The Sizewell C Project

9.73 Comments at Deadline 7 on Submissions from Earlier Deadlines and Subsequent Written Submissions to ISH1-ISH6 - Appendices

APPENDIX J: LANDSCAPING AND NOISE LETTERS TO FERN, MOLLETTS FARM AND MR & MRS LACEY

Figure 1: Additional receptor location at Mollett's Farm

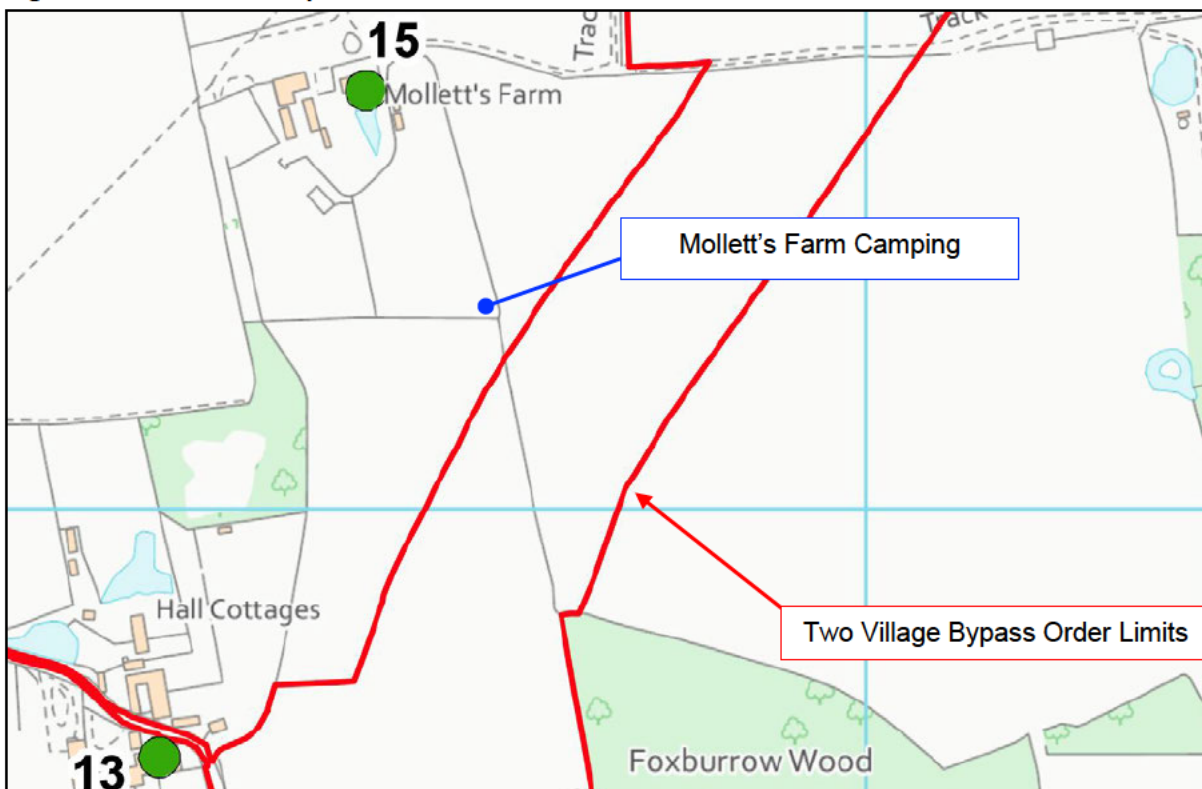
The calculations have been undertaken at receptor location 15, representing Mollett's Farm. At the request of Mollett's Farm's owners, an additional receptor location has been included in the calculations to represent their camping area. The position of the additional receptor point is shown in Figure 1.

DRAWING TITLE:
TWO VILLAGE BYPASS
PROPOSED LANDSCAPE MASTERPLAN
AND FINISHED LEVELS
SHEET 2 OF 2

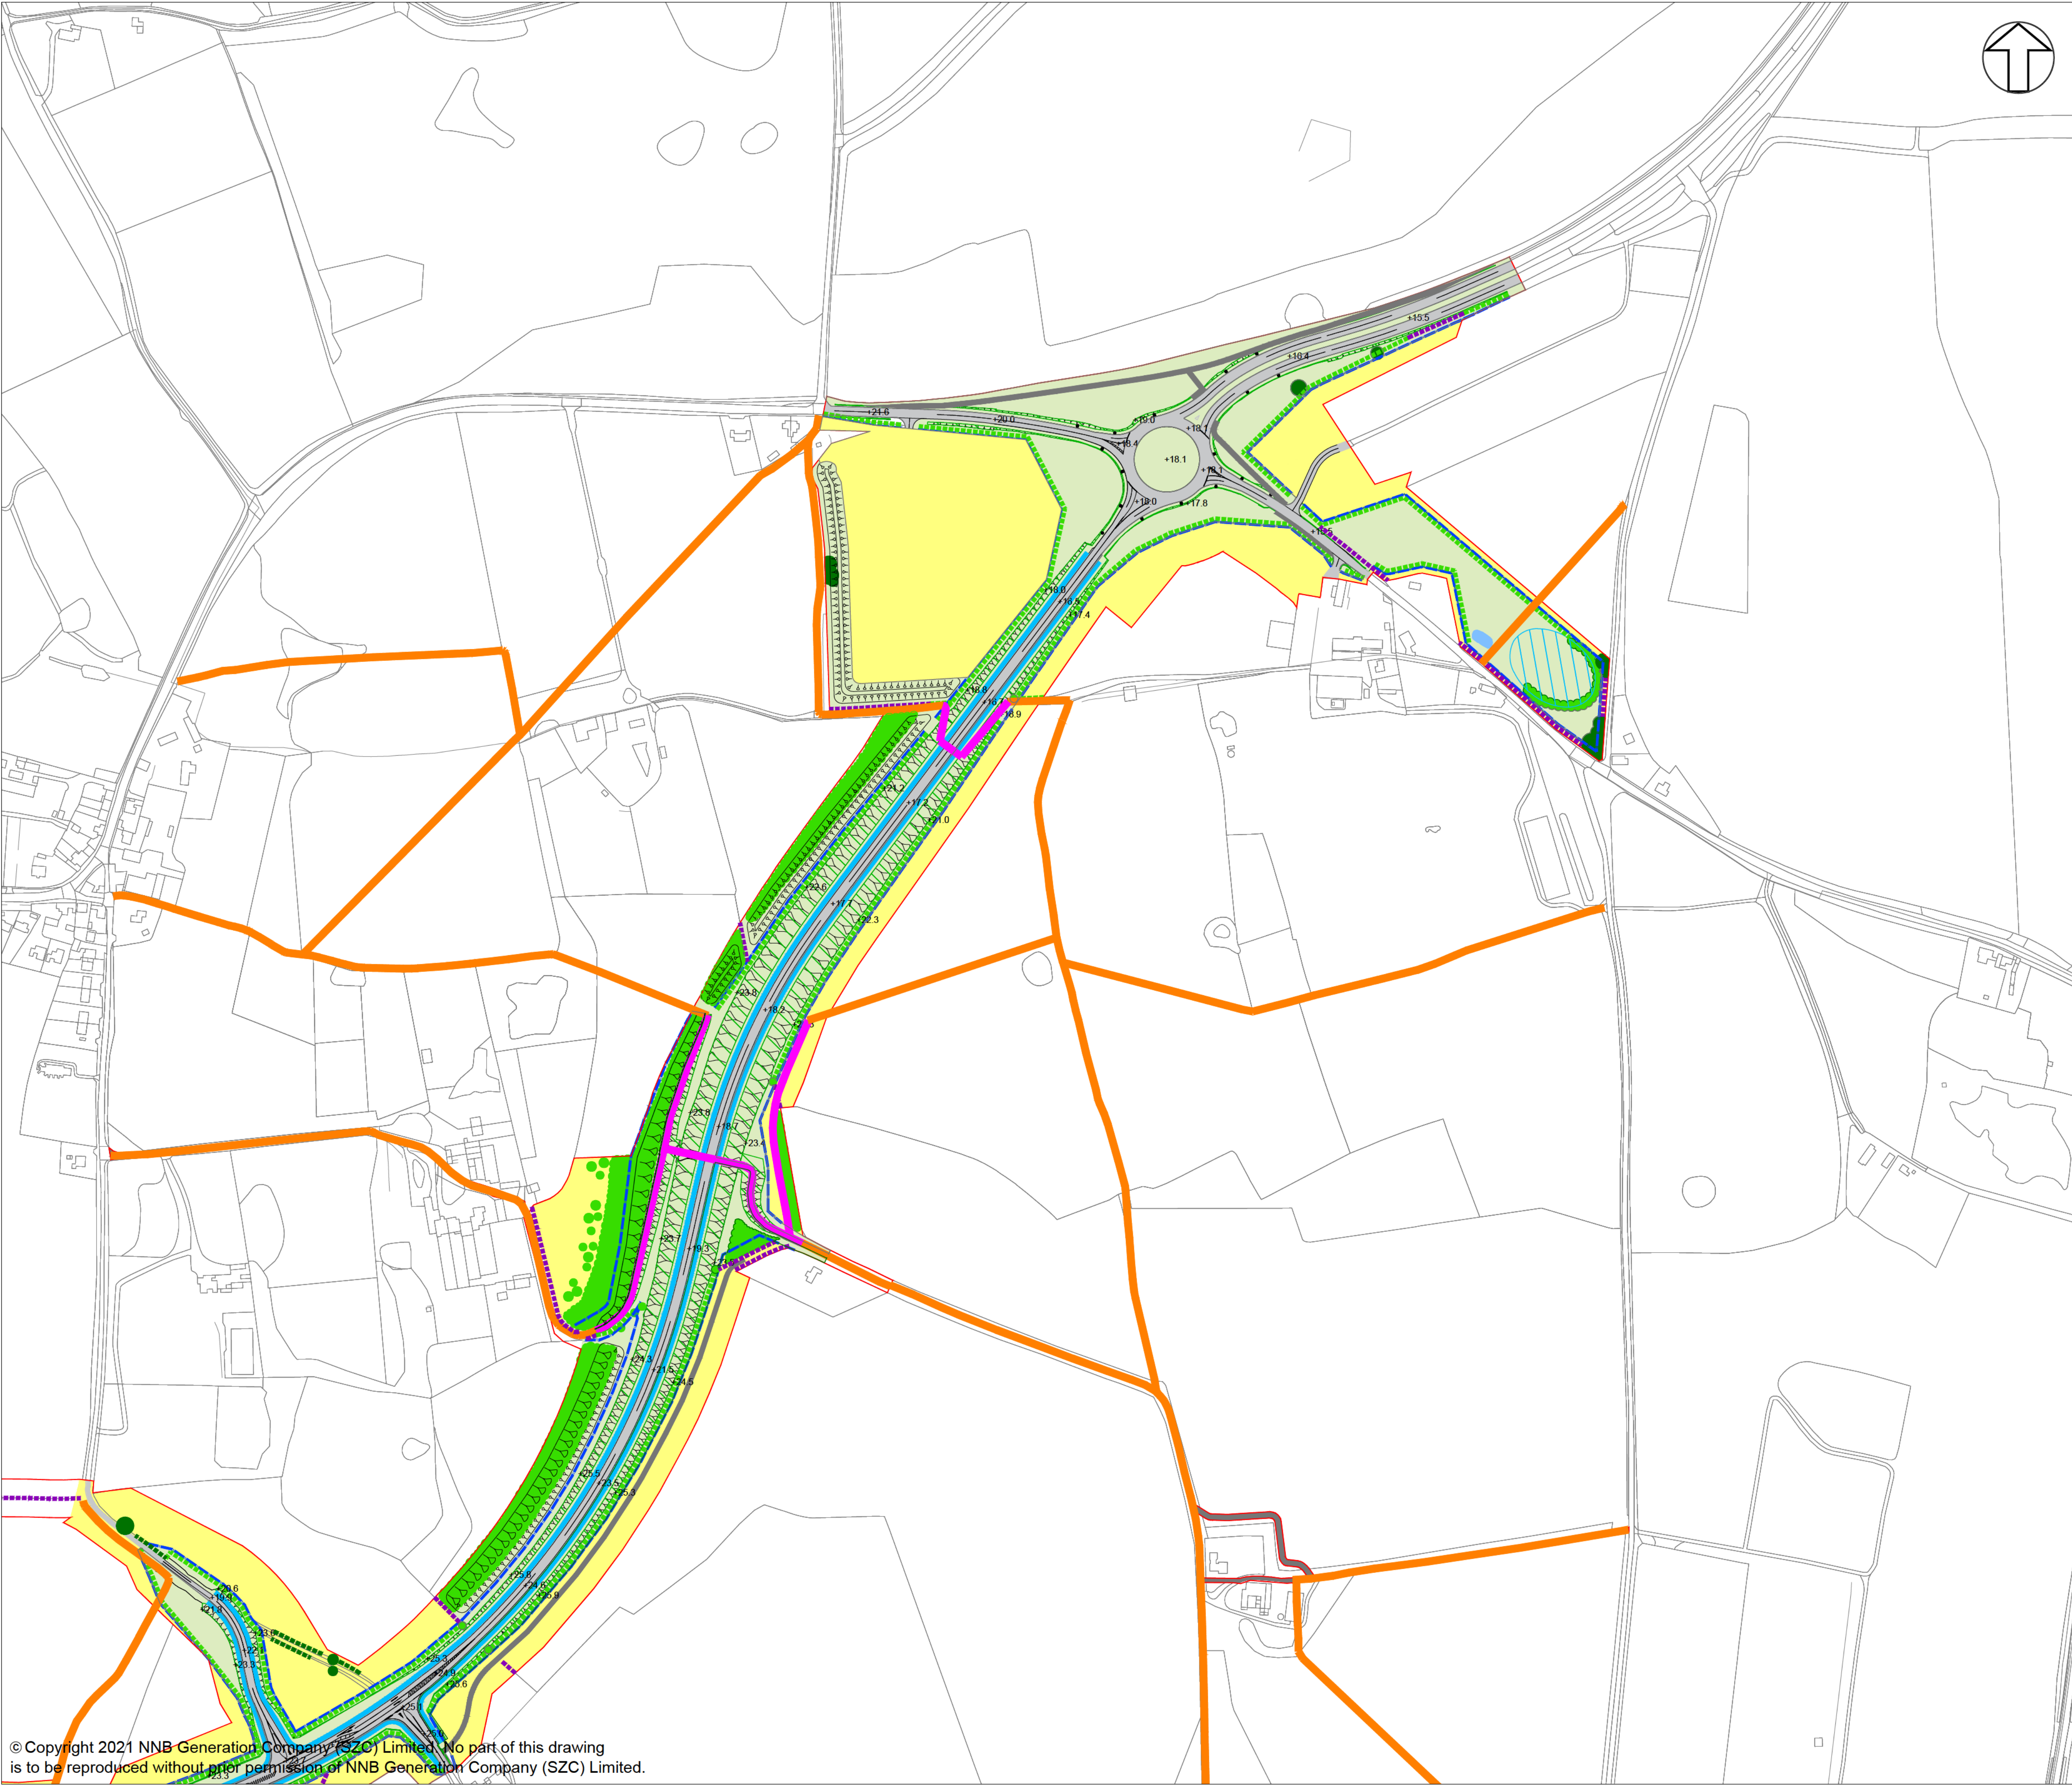
The revised landscape proposals as set out on the accompanying plan, indicate a proposed 2m high bund along the western edge of the two village bypass. This is shown running along the western and southern edges of the proposed contractor's compound and then along the top of the cutting slope to tie into the ramp sloping up to the Foxburrow Wood overbridge. The plan shows planting on the west facing slopes of the bund as well as between the bund and the DCO boundary, this will provide softening of the structures in views from Mollett's Farm. This aligns with the Saxmundham bypass bunding that was discussed previously. Conversations are currently ongoing with the ecology team to develop an appropriate planting mix for the proposals, this will be shared along with planting size when we present the proposals during our next meeting.

With regard to footpath connections from Mollett's Farm to the surrounding area, space has been allowed for the current permissive route from the corner of the camping field to continue to connect into the rights of way network and to access the overbridge to cross the proposed bypass to the south. In addition, the latest highway proposals repurpose the stopped up section of the A12 to the north of the farm as a footpath connection and propose a crossing point to the east of the roundabout and a footpath down to Friday's Farm. With the reduced traffic on the A12, the public footpaths that run north from Mollett's Farm would connect to this new route to provide a further alternative route to Friday's Farm.

TWO VILLAGE BYPASS
PROPOSED LANDSCAPE MASTERPLAN
AND FINISHED LEVELS
SHEET 2 OF 2

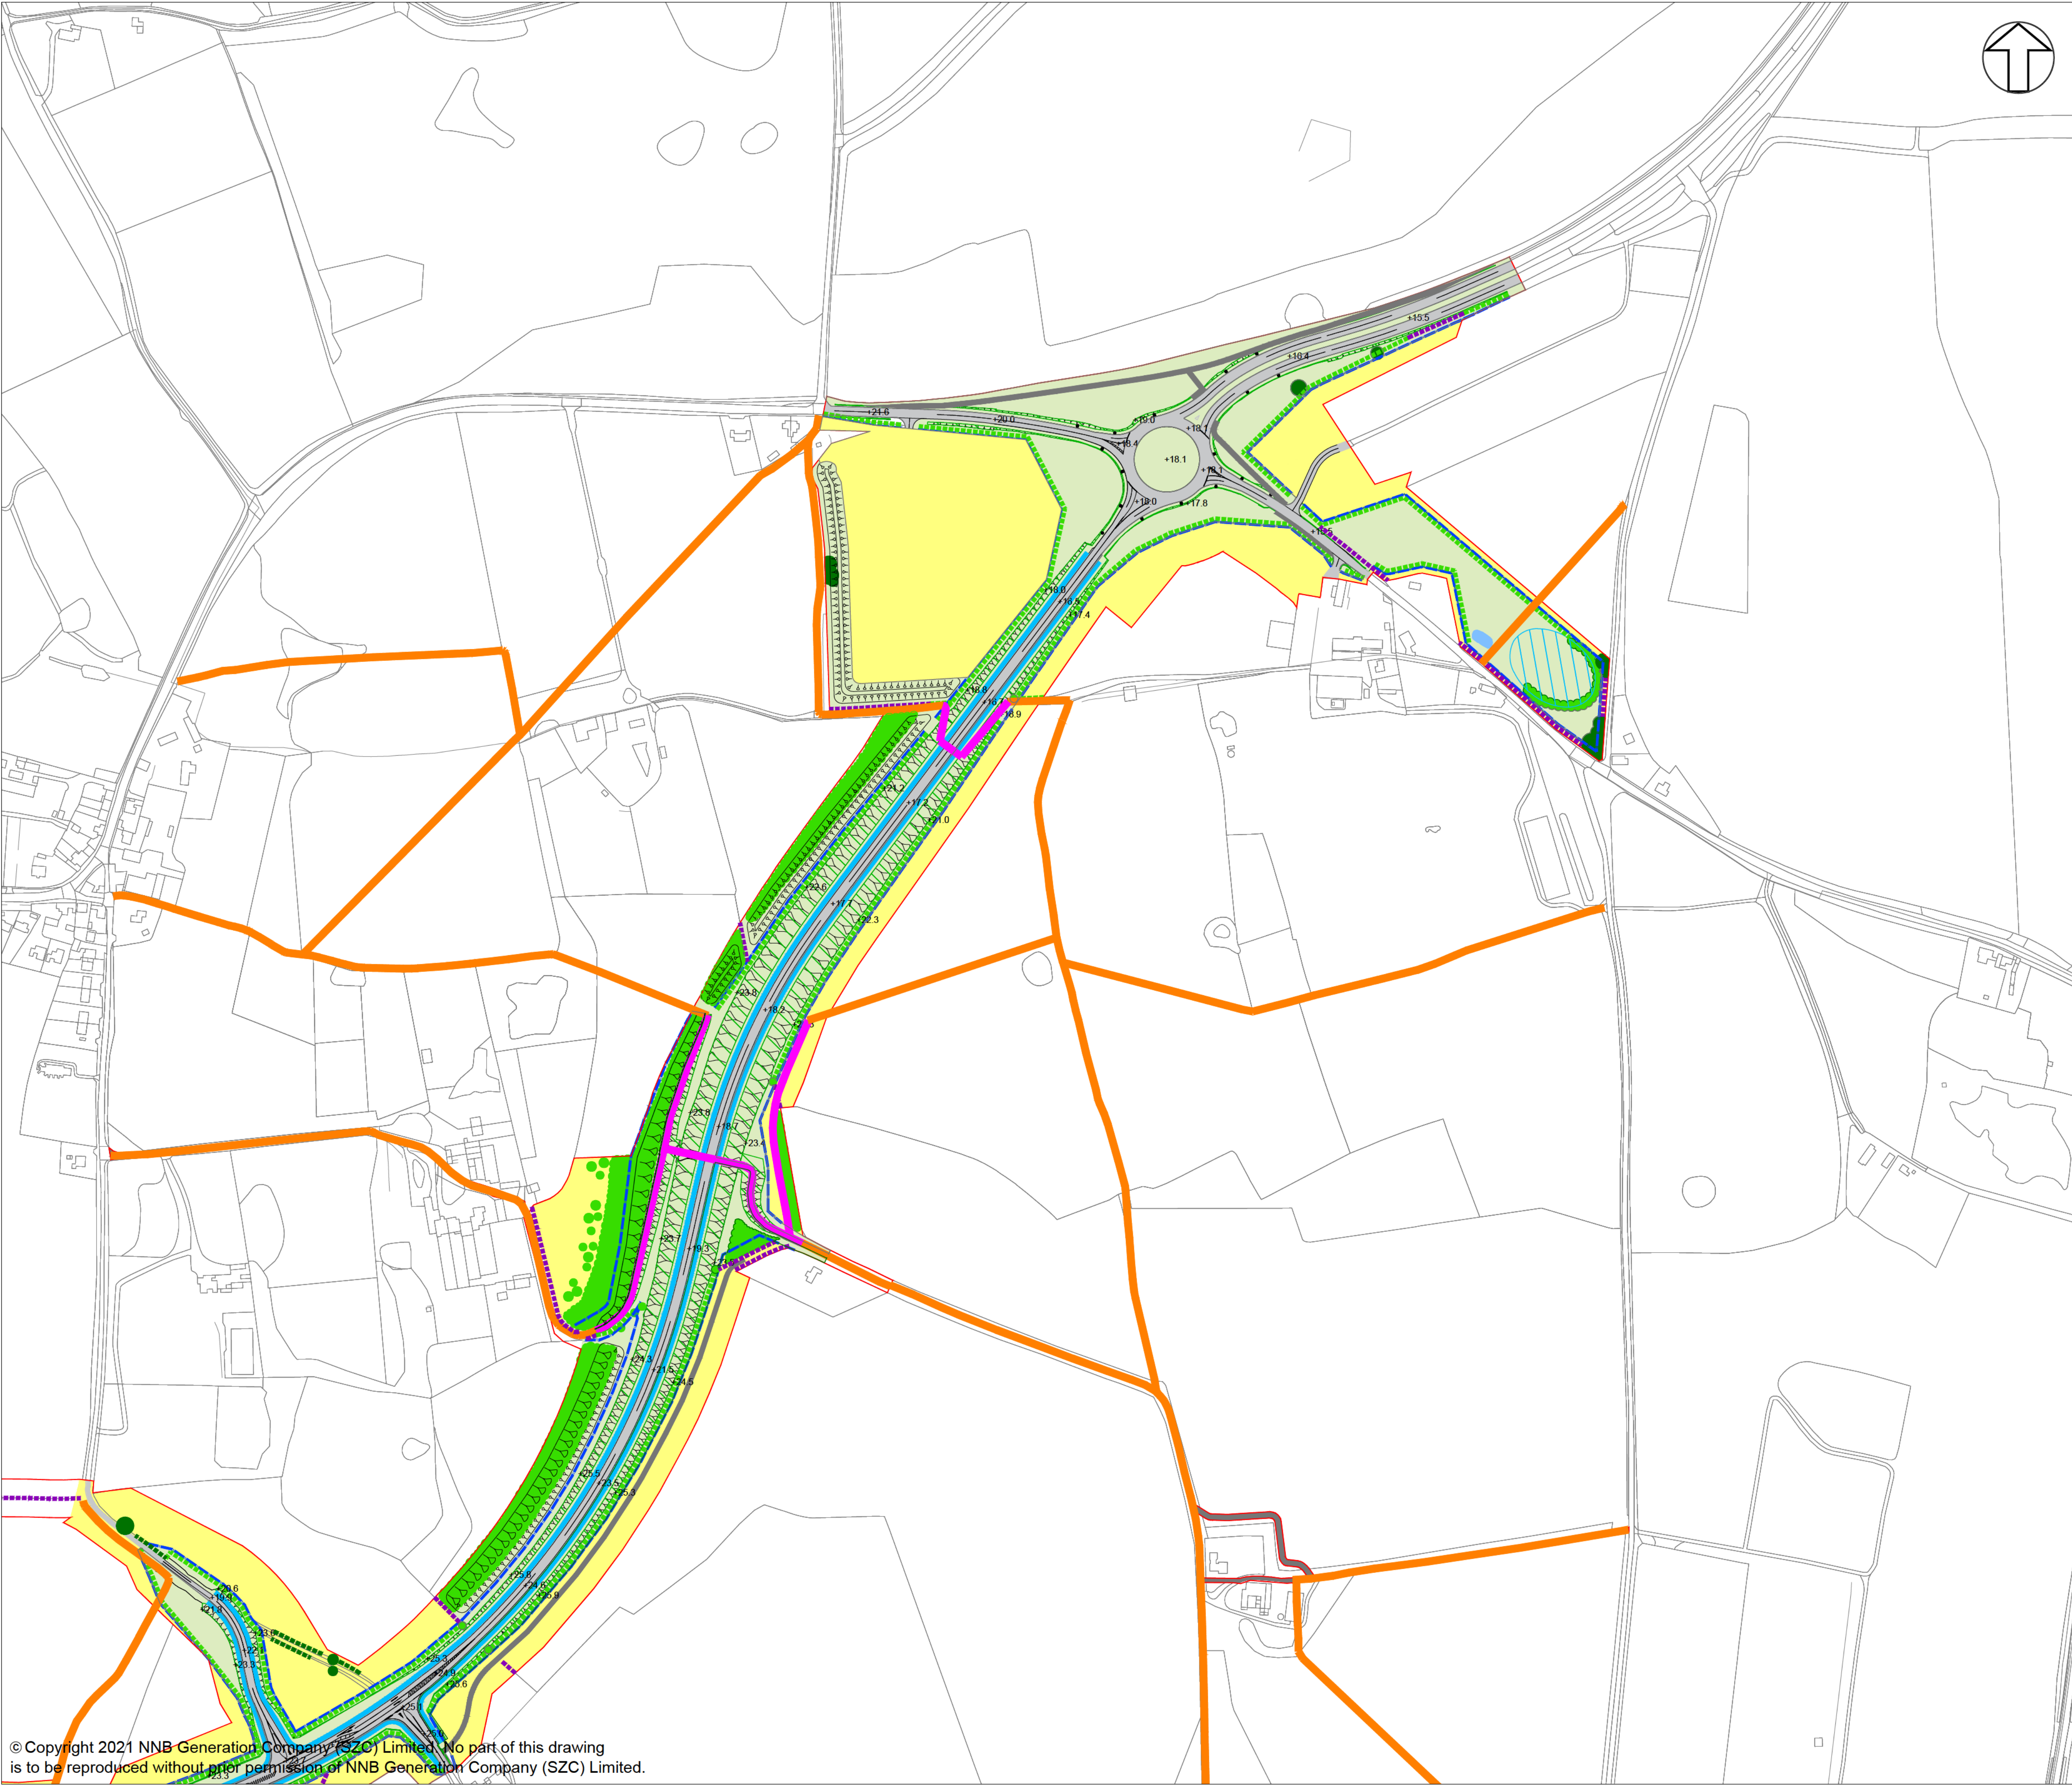
The attached plan shows the revised landscape proposals for your consideration. The revised proposals, for further discussion, indicate a proposed 2m high bund along the western edge of the proposed two village bypass, combined with a slackening of the slopes associated with the ramp up to the proposed overbridge. The bund is shown running along the western and southern edges of the proposed contractor's compound to the east of the proposed roundabout and then along the top of the cutting slope to tie into the ramp sloping up to the Foxburrow Wood overbridge. The slacker slopes of the ramp to the overbridge would allow them to be planted, which would provide a visual screen from the overbridge. A further 2m high bund is then shown running south from the overbridge to the retained hedgerow that links to the corner of Pond Wood.

The plan indicates planting on the west facing slopes of the bunds, on the slopes of the overbridge ramps and between the bund and the DCO boundary to provide softening of the structures in views from the Farnham Hall properties. In addition, the plan shows a close board fence running to the west of the footpaths running up the ramps to the overbridge in order to prevent overlooking of the Farnham Hall properties by people using the overbridge while planting becomes established.
